PIC16F684 Rev. A Silicon/Data Sheet Errata

The PIC16F684 parts you have received conform functionally to the Device Data Sheet (DS41202D), except for the anomalies described below.

FIGURE 8-2: COMPARATOR C1 OUTPUT BLOCK DIAGRAM

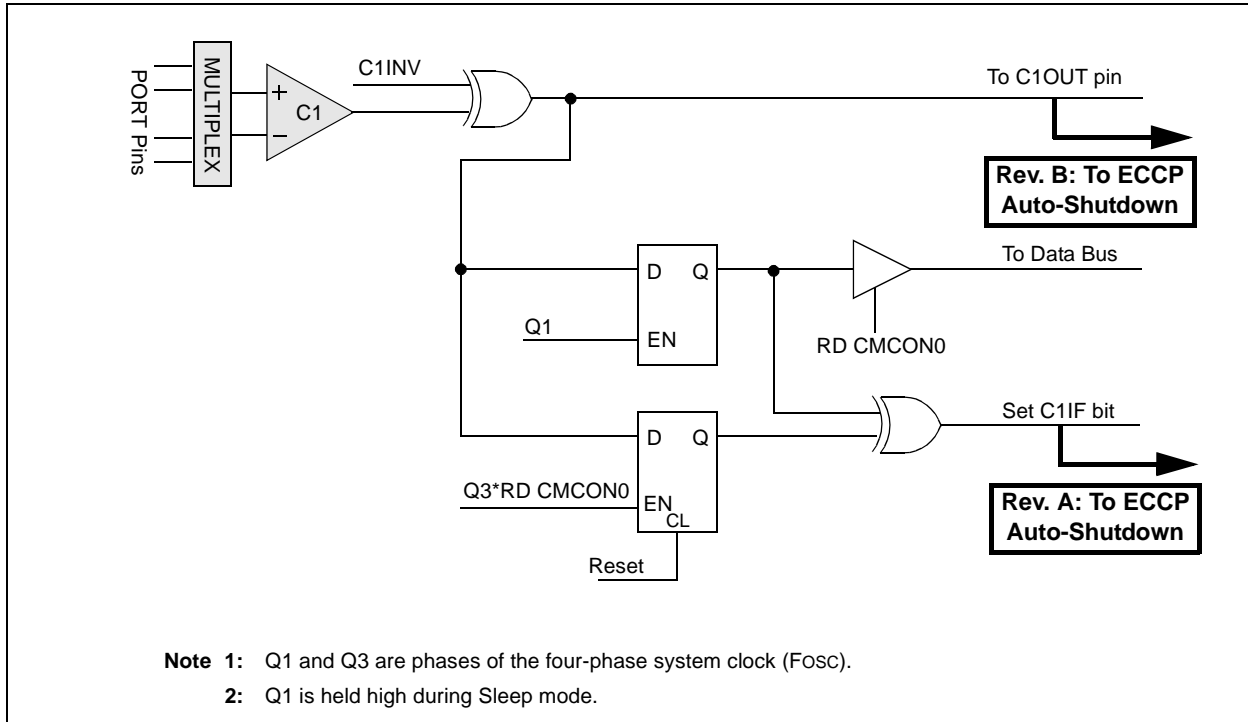
The PIC16F684 Rev. A4 silicon for the ECCP Auto-Shutdown is connected to the C1IF and C2IF flags. See Figures 8-2 and 8-3 on the following page.

Rev. A4's auto-shutdown connection to C1IF and C2IF causes the auto-shutdown to incorrectly operate synchronously. Additionally, reads of CMCON0 will incorrectly clear an auto-shutdown event.

- 1) Poll the CxOUT bit until it is low.
- 2) Read CMCON1 to precondition CxIF.
- 3) If CMCON0 is read while CxOUT is changing, repeat steps 1 and 2.

The Silicon Rev. B2 device (now shipping) has moved the auto-shutdown connection from CxIF to CxOUT. This will eliminate the synchronous shutdown and simplify the use of the comparator for a shutdown event. Figure 1 shows the function of auto-shutdown before and after the device revision.
